LIRIS COMPRESSOR N°:1

Modifications to the cold head motor control board.

Roberto Martínez Rayón September 2018

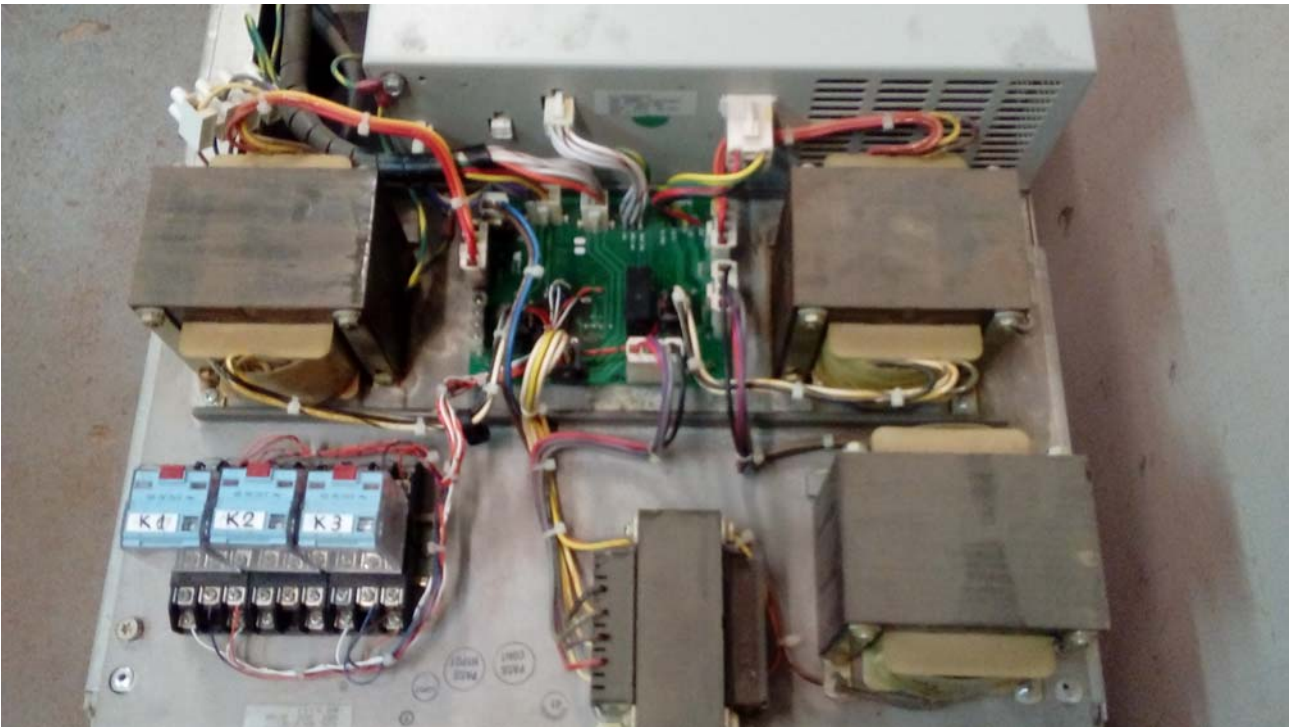
Solution : The relays of the cold head motor control board have been installed outside the cold head on a DIN rail. The original relays K1 and K3 were burned and affected the card where they were soldered.

Three relays K1,K2 and K3 have been installed on a DIN rail next to the control card and wiring interconnection (Ref: 8135167G001).

-- K1 and K3 are connected to the control board with new cables.

-- K2 has also been installed on the DIN rail, for possible future failure, but is not connected to the board as the original relay is in good condition.
